# Thoughts on NEI Comments on Draft Regulatory Issue Summary (RIS) - Considerations in Licensing High Burnup Spent Fuel (HBF) in Dry Storage And Transportation

Huda Akhavannik  
NMSS/DSFM/SFLB

May 18, 2015  
Public Meeting with NEI

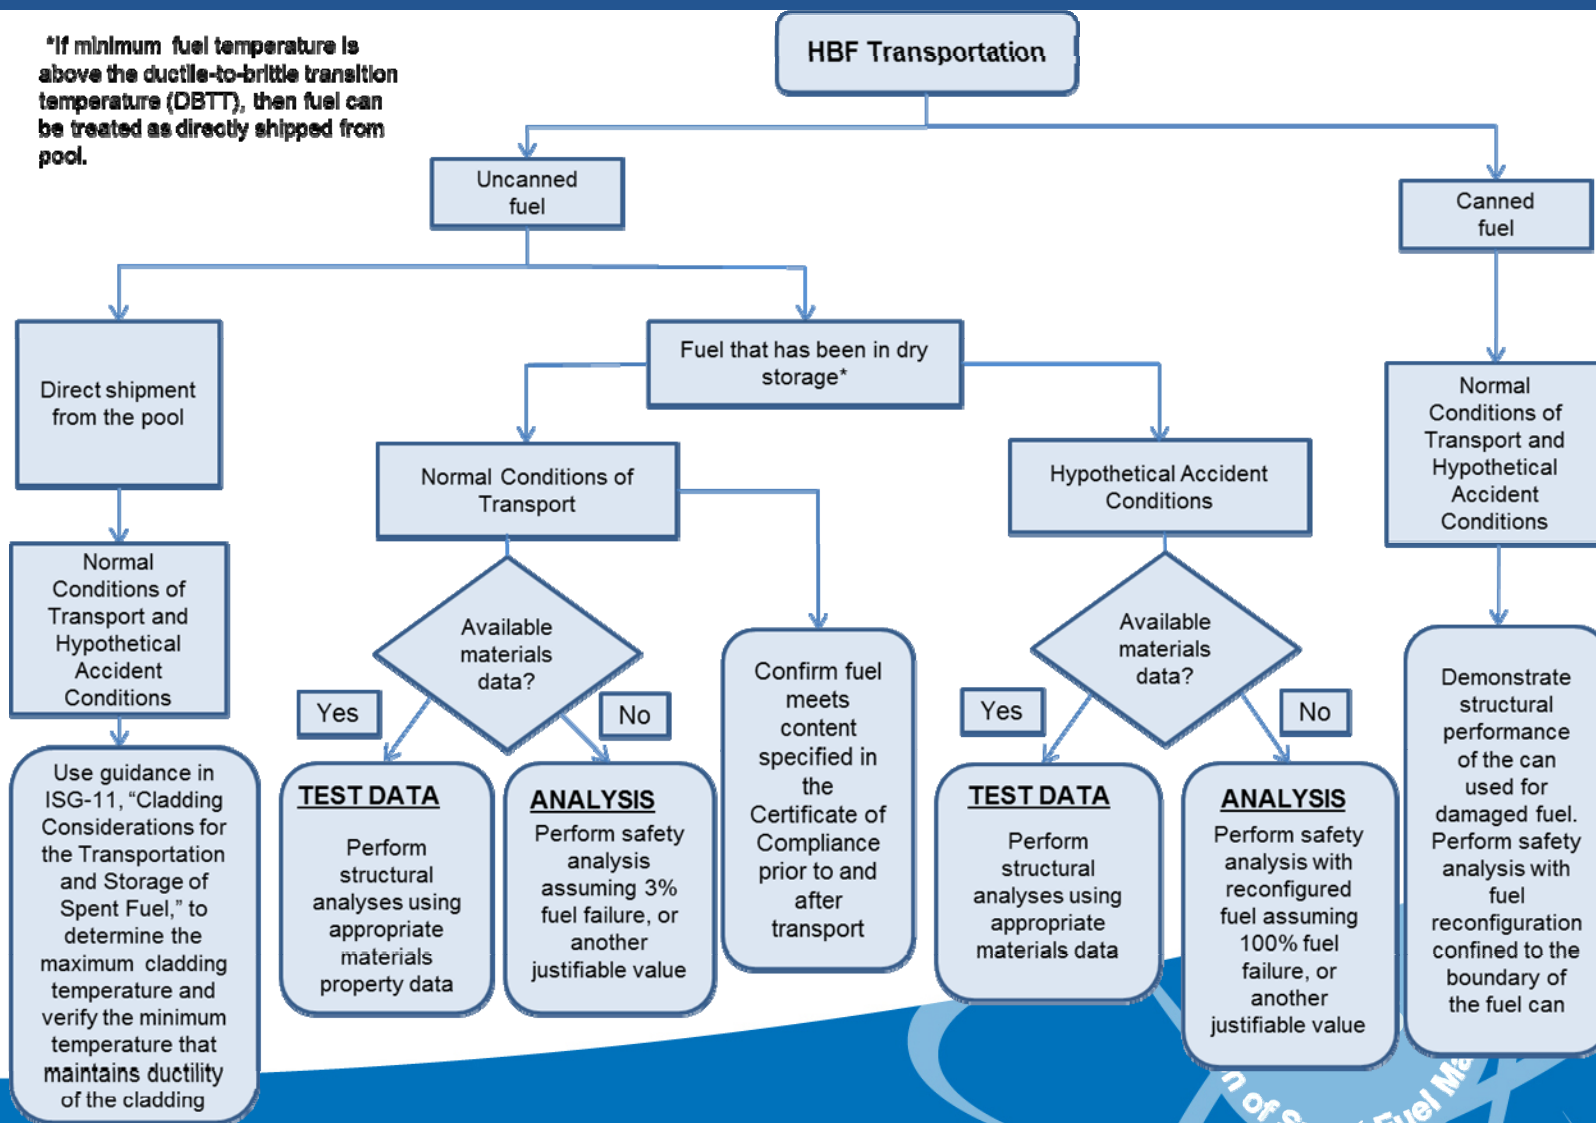
- Table Comment #2, Part 2 and Table Comment #14
- Why are different paths established for fuel directly shipped from the pool and fuel that has been in dry storage?
- This should be revised based on whether the fuel temperature is above or below the DBTT at the time of shipment
- Concept of hydride reorientation and DBTT is explicitly stated in flowchart (asterisk)
- Already have application using approach from the spent fuel pool
- Keeping statement as-is

- Concept of hydride reorientation and DBTT is explicitly stated in flowchart (asterisk)
- Already have application using approach from the spent fuel pool
- Keeping statement as-is
